Addendum No. 1

Site Improvements at Franklin Elementary School

Bid Number 159-17/18

1 CODE ANALYSIS & ACCESSIBILITY SITE PLAN
 SCALE: 1" = 20'-0"

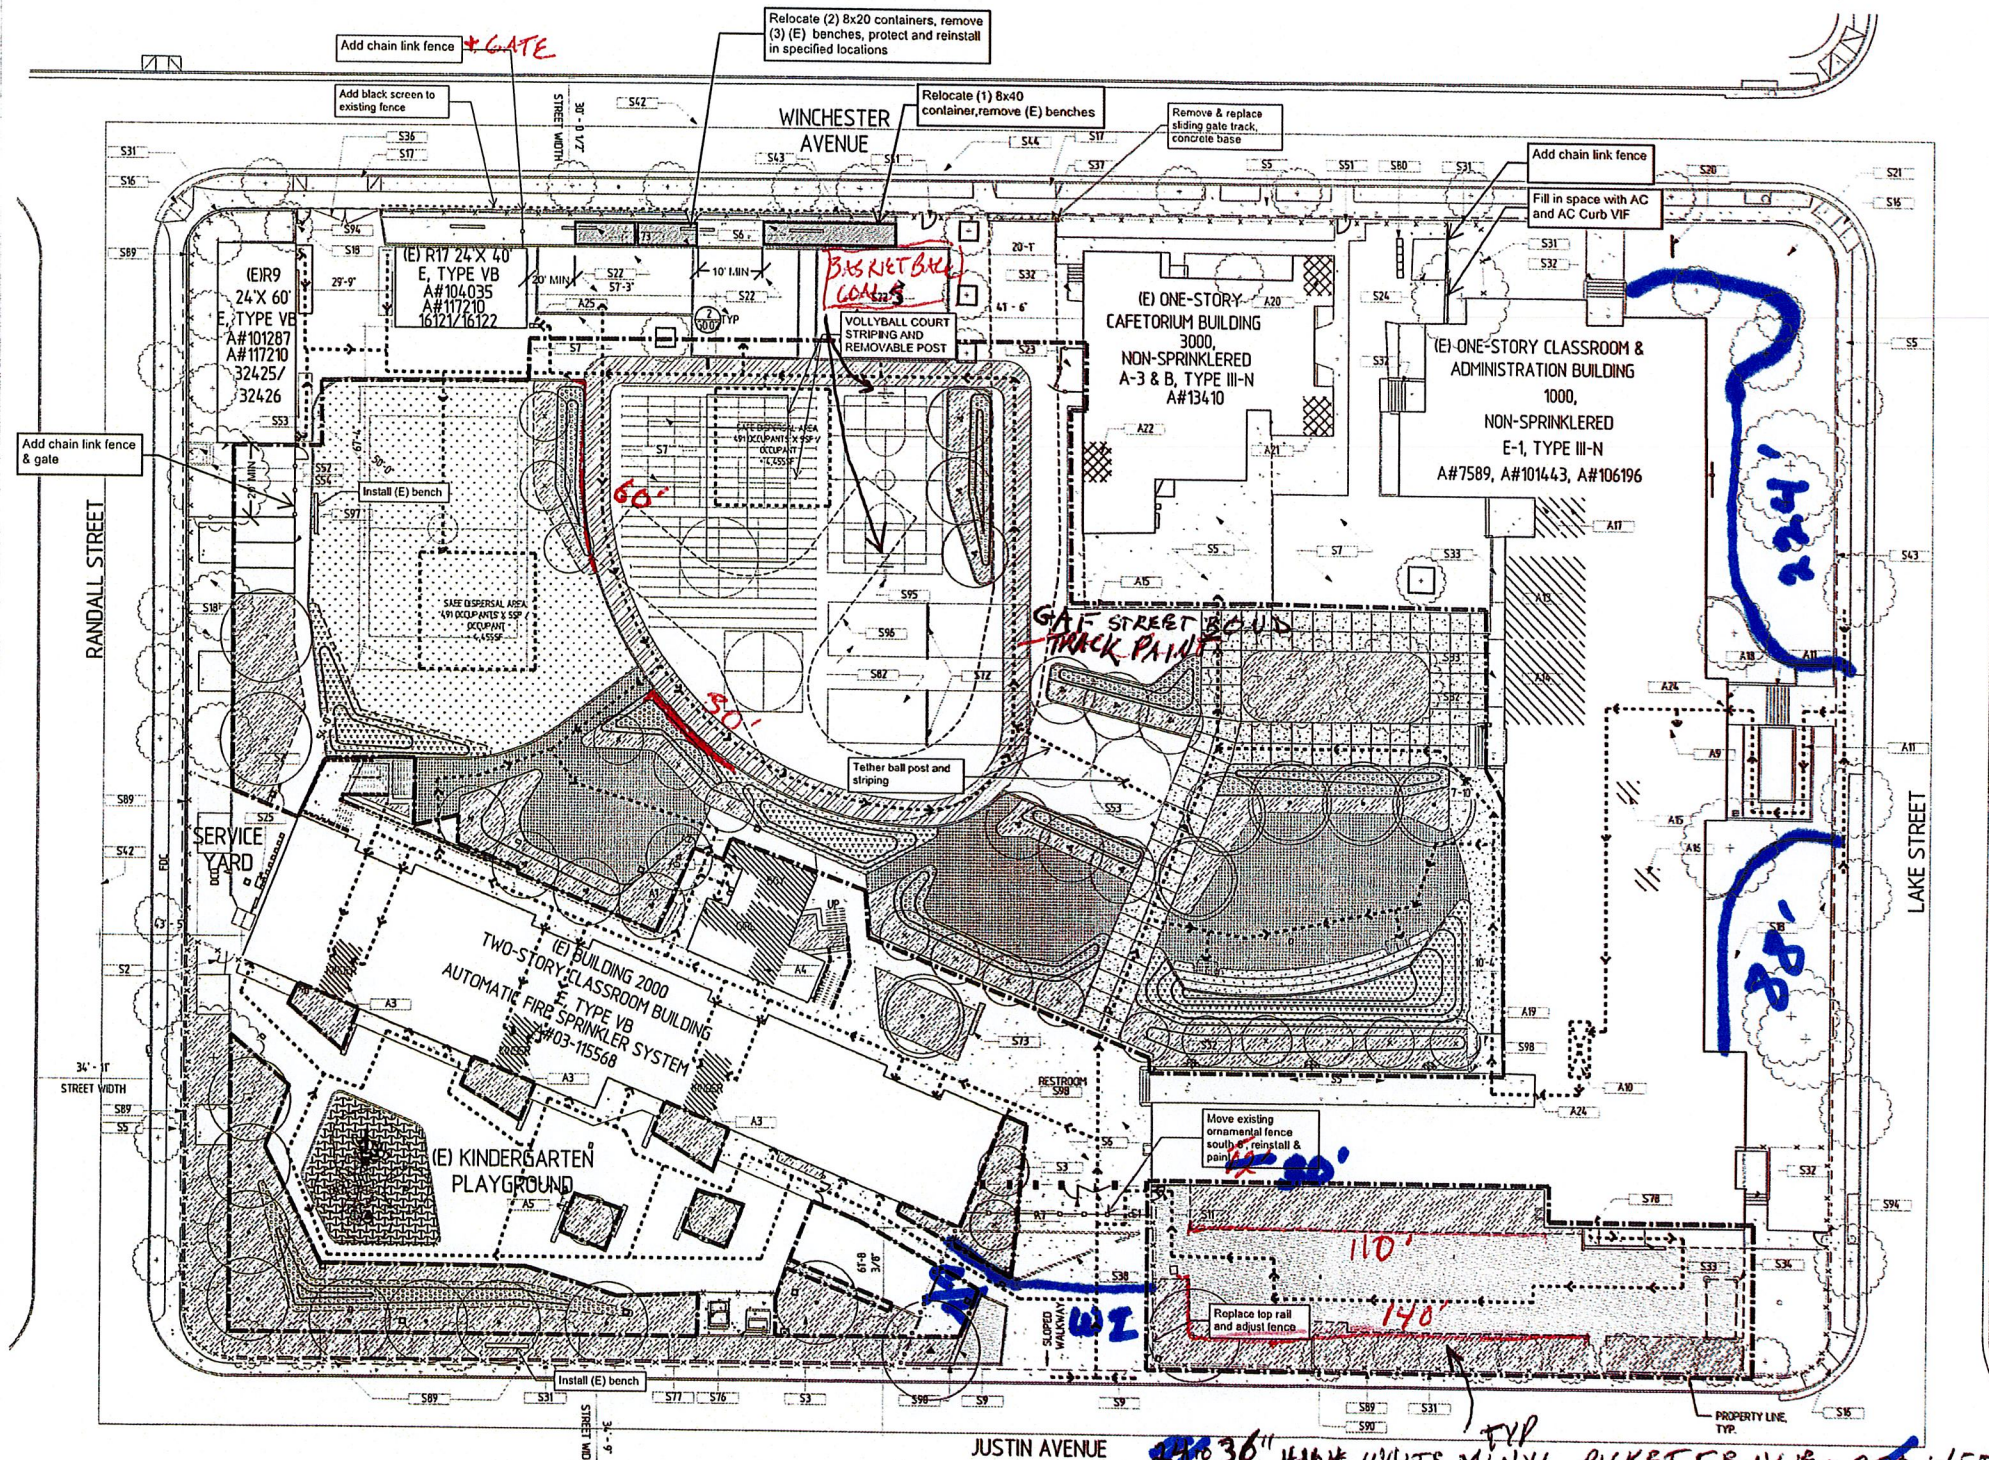
- Add approximately 320 linear feet of Picket Fence, per the revised detail to bring the total to approximately 670 linear feet.
- Add approximately 10' of Chain Link Fence, per revised detail
- Add 8 hours of Labor to for 24 3" Eye Hook Lag Bolts

ADD 320 1/2 FT PICKET FENCE
ADD 10' C/L FENCE
ADD 8 HRS LABOR + 24 3" EYE HOOK LAG BOLTS
